ADDENDUM NO. 4
November 29, 2021

2022 MECHANICAL WORK
EISENHOWER ACADEMY
JOLIET, ILLINOIS
FOR
JOLIET PUBLIC SCHOOLS DISTRICT 86
JOLIET, WILL COUNTY, ILLINOIS
PROJECT NOS. 6-1621-40

2022 MECHANICAL WORK
T.E. CULBERTSON ELEMENTARY SCHOOL
JOLIET, ILLINOIS
FOR
JOLIET PUBLIC SCHOOLS DISTRICT 86
JOLIET, WILL COUNTY, ILLINOIS
PROJECT NOS. 6-1621-39

FIRST FLOOR PLUMBING PLAN

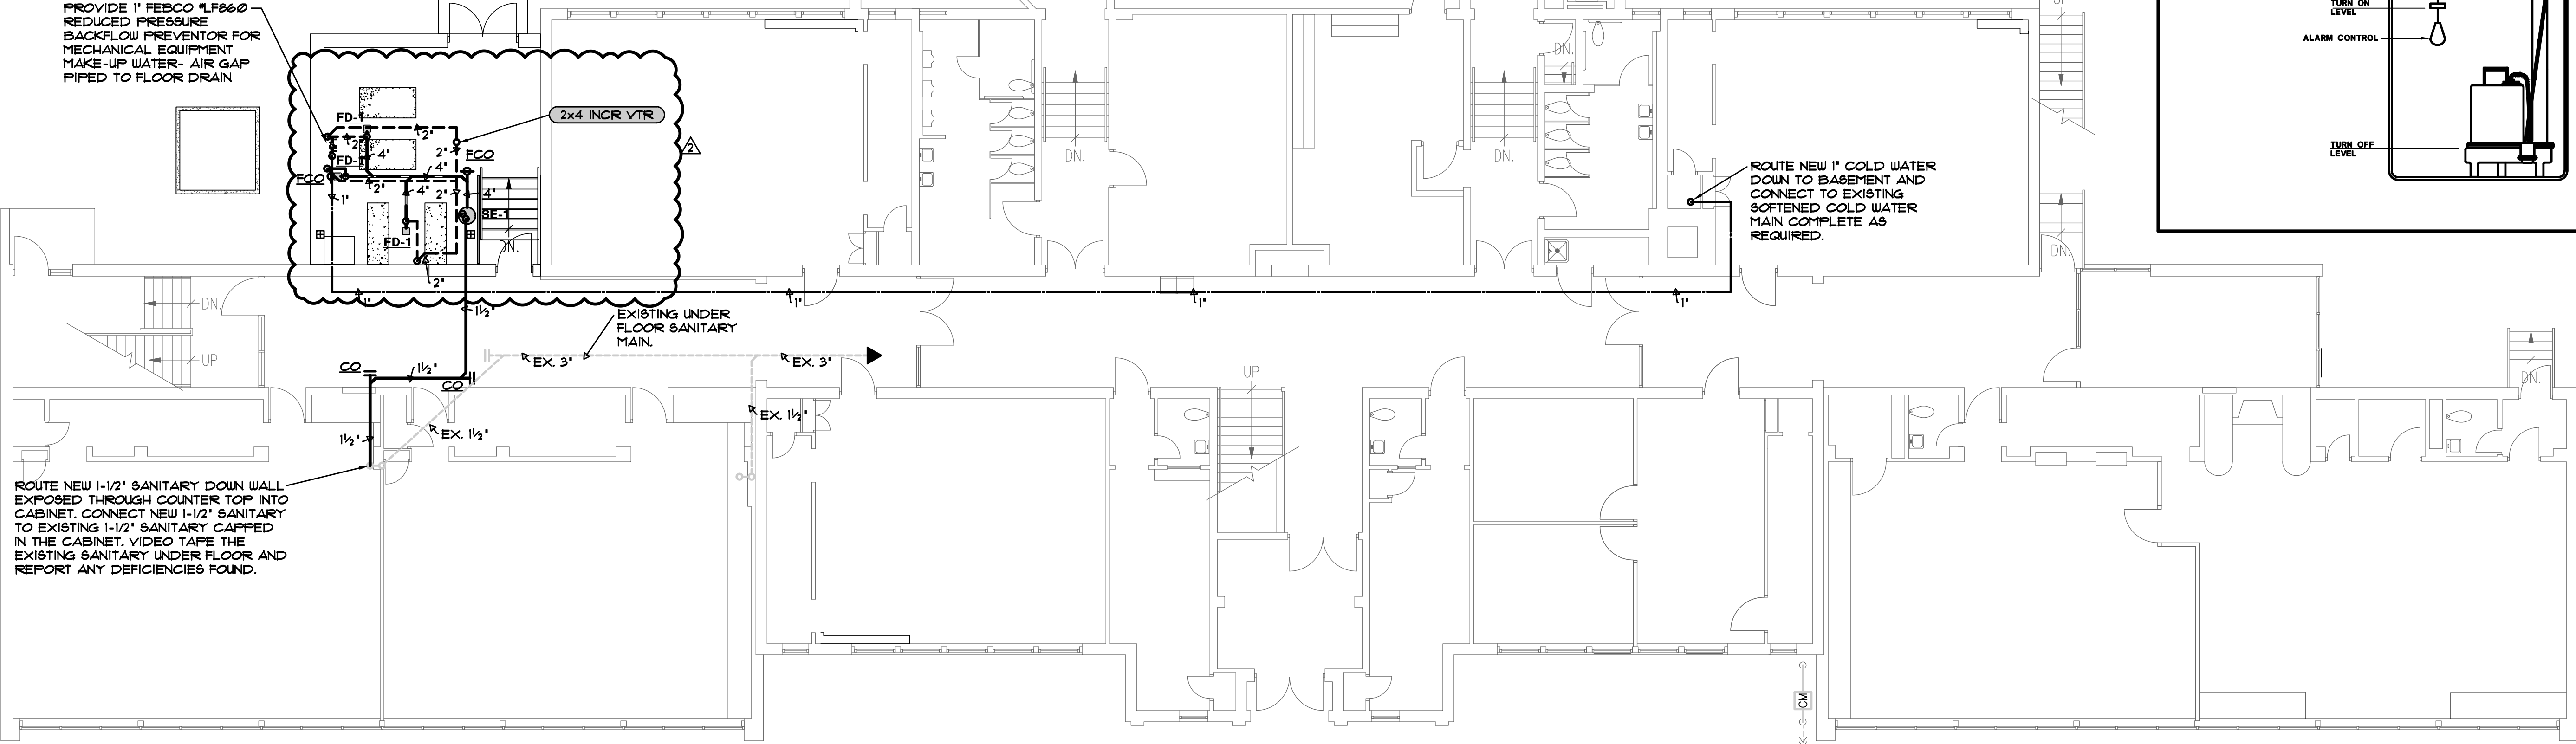
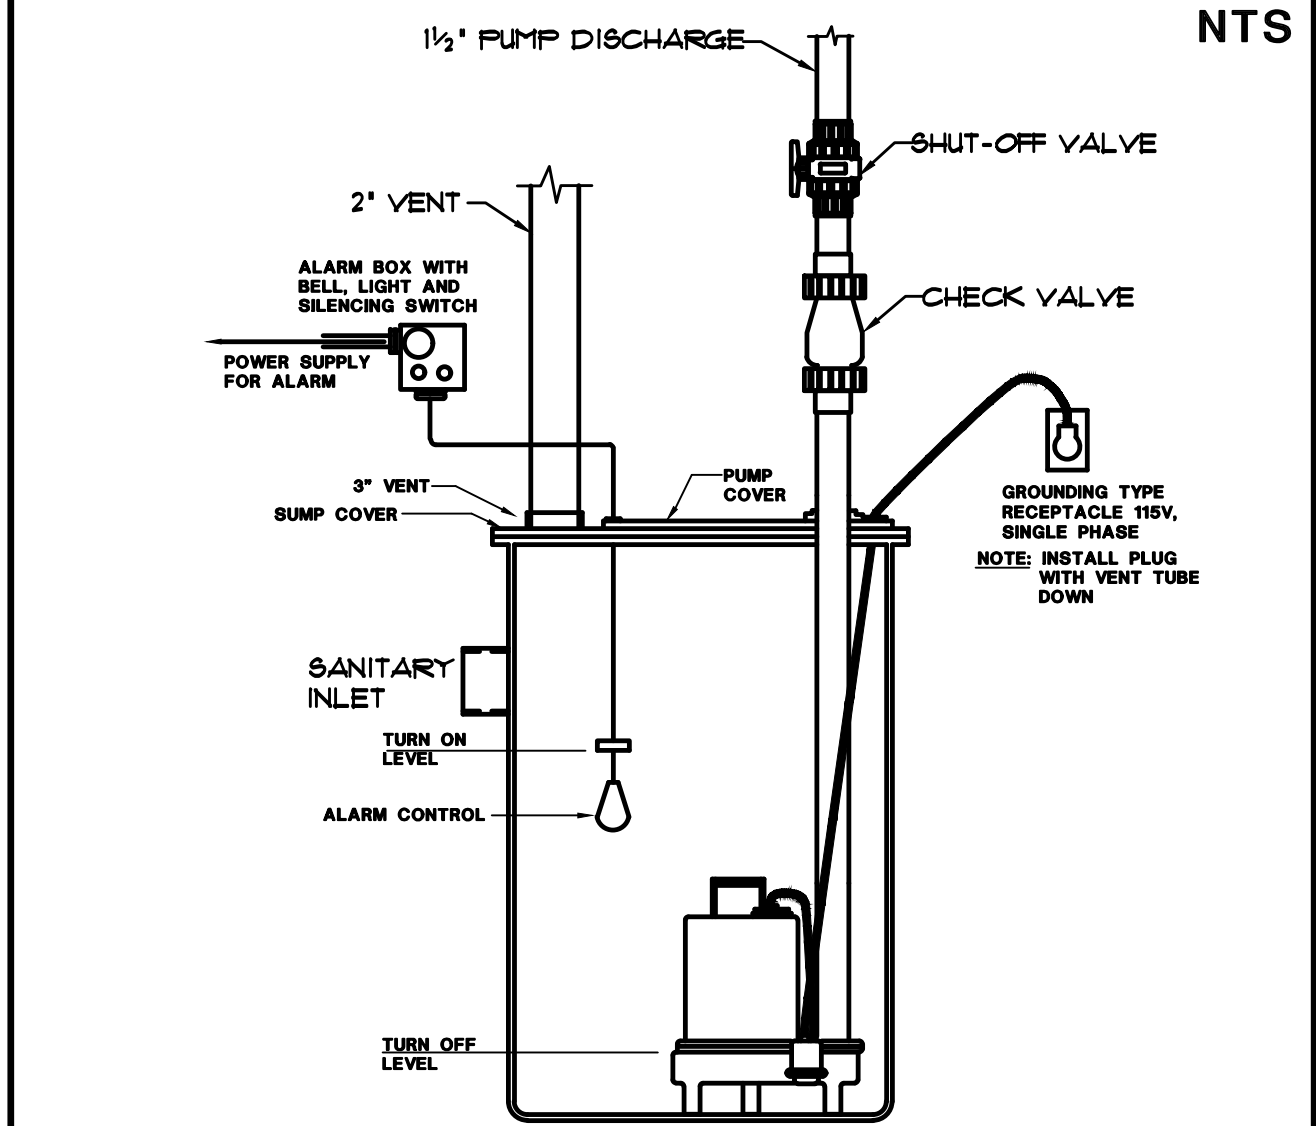
1. First Floor Electrical Power Plan, Room 114; REVISE power location for new sewage ejector location per revised Sheet P-1.2 dated 11-29-2021 included as part of this Addendum.

FIRST FLOOR MECHANICAL HVAC PLAN - AREA B

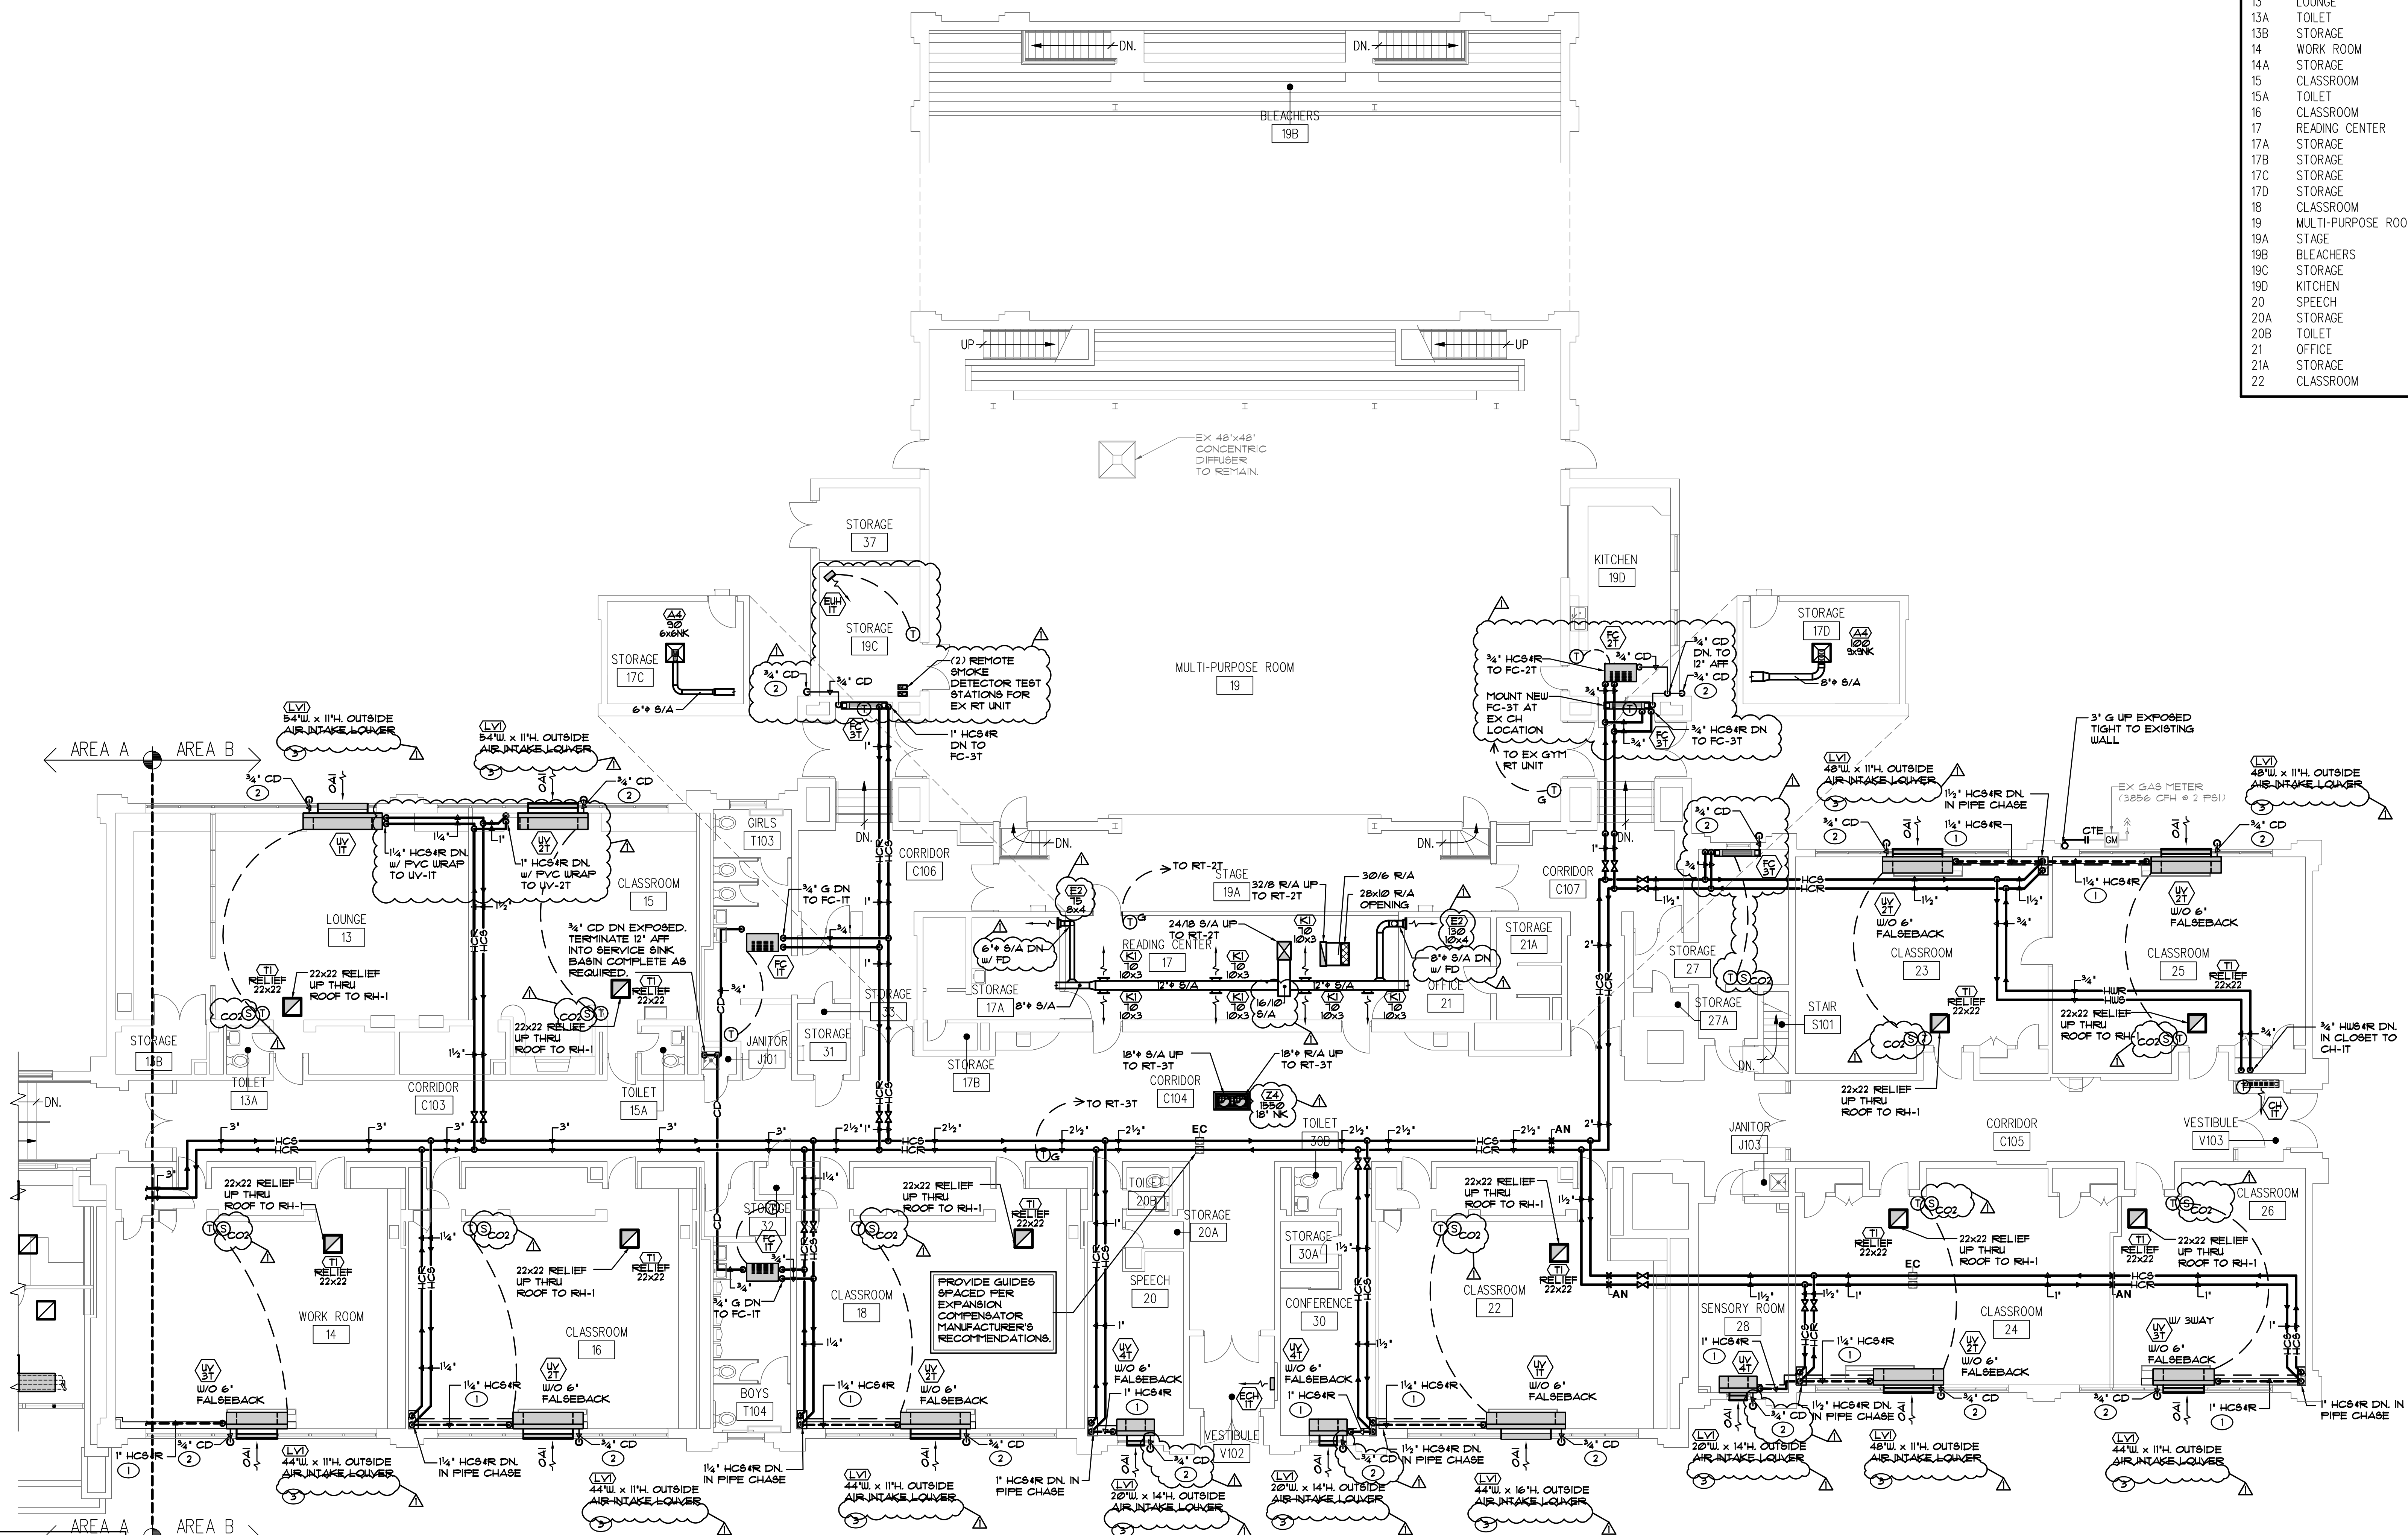
1. First Floor Mechanical Demolition Plan – Area B, Room 27; DELETE Sheet Note “3” and REVISE the note pointing to the mechanical equipment to be removed as follows:
“Remove existing fan coil unit and associate abandoned heating piping, condensate piping, thermostat, controls, electrical connections, etc. complete as required, VIF”
2. First Floor Mechanical Demolition Plan – Area B, Room T104; DELETE Sheet Note “6” and REVISE the note pointing to the mechanical equipment as follows:
“Abandon existing convector”
